Application for Works Approval

Part V Division 3 of the *Environmental Protection Act 1986*

Works Approval Number	W6750/2022/1
Applicant	Evolution Mining Limited
ACN	084 669 036
File number	DER2022/000472
Premises	<p>Kundana Gold Mine</p> <p>Legal description</p> <p>Mining tenements M16/72, M16/73, M16/87, M16/97, M16/157, M16/308, M16/309, M15/669, M15/993, M16/428, M24/924, L16/39, L16/105 and L16/106</p> <p>Kalgoorlie WA 6430</p> <p>As defined by the premises maps attached to the issued works approval</p>
Date of report	7 March 2023
Decision	Works approval granted

Figure 1: Hornet Open Pit proposed pipeline

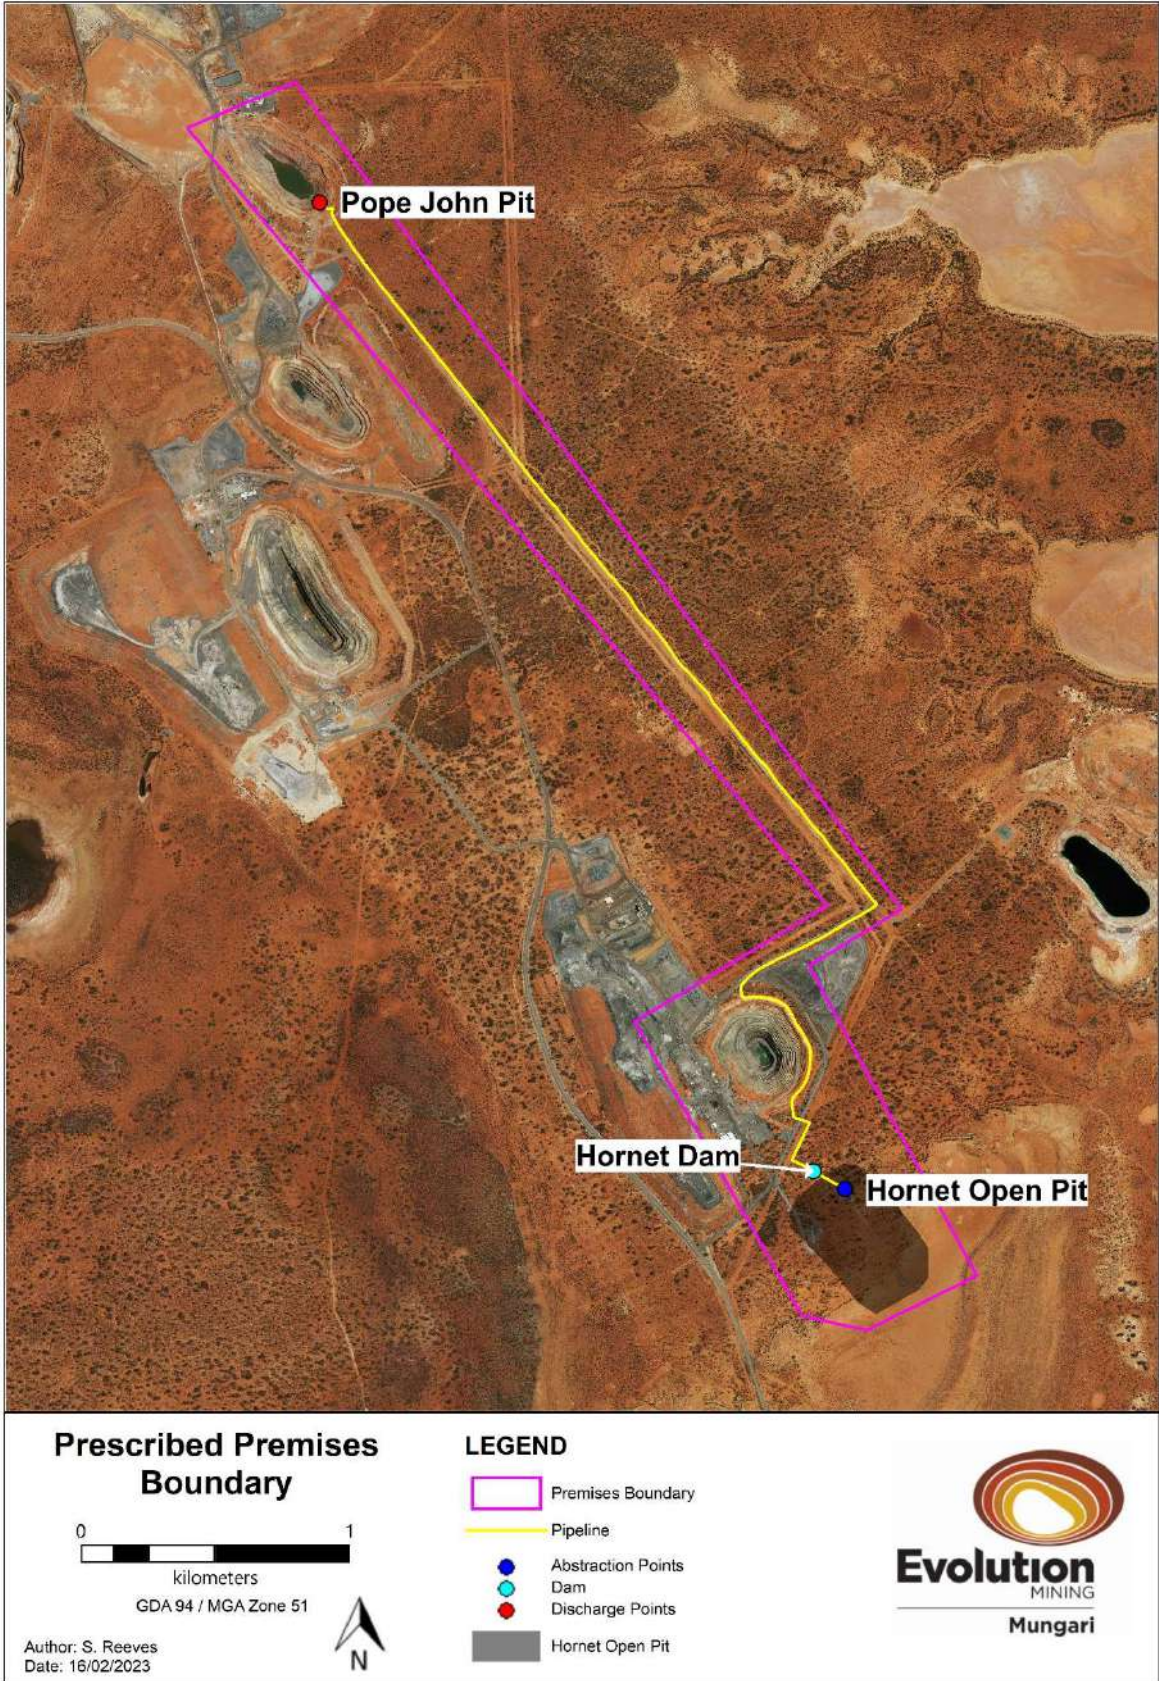
Schedule 1 Figure 1	Labelled map has been provided. Hornet dam was incorrectly labelled.	The updated maps have been included in the decision report and works approval.
Schedule 1, Figure 2	Labelled map has been provided. Hornet dam was incorrectly labelled.	The updated maps have been included in the decision report and works approval.
